Access Compliance Report

Public Rights-of-Way

(Curb Ramps)

Intersection ID: 24621	Main Street: HUGH_FOREST_RD	Cross Street: WALTHAM_LN	Location: SE
ADA ID: BBA88AC015A6	Ramp Type: PerpDiag	Initial Pass/Fail: Fail	Overall Compliance: No
Severity Score: 10			
Codes/Mitigation Info/Possible Solution		Field Measurements/Component Compliance

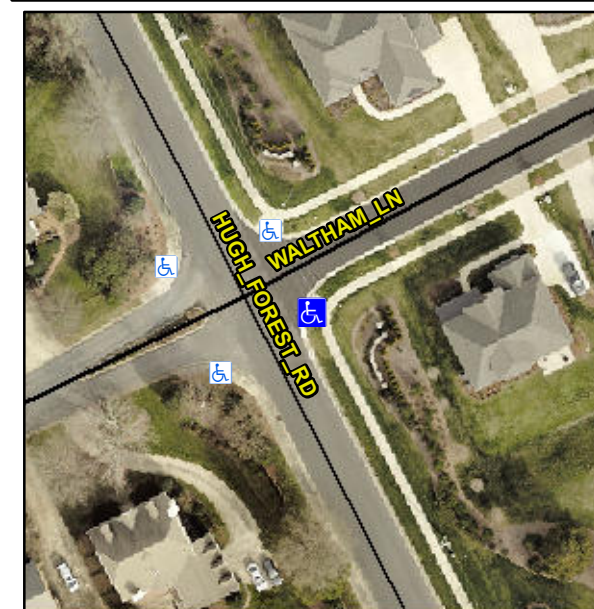
Not Found, R304.5.1, R304.5.3

Compliance	Description	Data	Compliance	Description	Data
N/A	Ramp Length (in)	95.0	Yes	Ramp Slope (%)	7.7
No	Ramp Width (in)	47.0	No	Ramp XSlope (%)	2.7
N/A	Flare Type LT	N/A	N/A	Flare Type RT	N/A
N/A	Flare Slope LT (%)	N/A	N/A	Flare Slope RT (%)	N/A
N/A	Flare Traversable LT?	N/A	N/A	Flare Traversable RT?	N/A
N/A	Landing Length (in)	N/A	N/A	DWS Provided?	N/A
N/A	Landing Width (in)	N/A	N/A	DWS Contrast?	N/A
N/A	Landing Slope (%)	N/A	N/A	DWS Length (in)	N/A
N/A	Landing X Slope (%)	N/A	N/A	DWS Full Width?	N/A
N/A	Landing Curb? (Y/N)	N/A	N/A	DWS Offset (in)	N/A
N/A	Shared Landing?	N/A			
N/A	Gutter Ponding?	N/A	N/A	Gutter Slope (%)	N/A
N/A	Gutter Lip Ht (in)	N/A	N/A	Gutter X Slope (%)	N/A
N/A	Painted X Walk1?	No	N/A	Painted X Walk2?	No
	X Walk 1 Direction	To N		X Walk 2 Direction	To W
N/A	X Walk 1 Width (in)	N/A	N/A	X Walk 2 Width (in)	N/A
	X Walk 1 Slope (%)	1.3		X Walk 2 Slope (%)	4.9
	X Walk 1 X Slope (%)	2.1		X Walk 2 X Slope (%)	0.7

Remove & Replace Curb Ramp With Two New Directional Ramps or Equivalent.
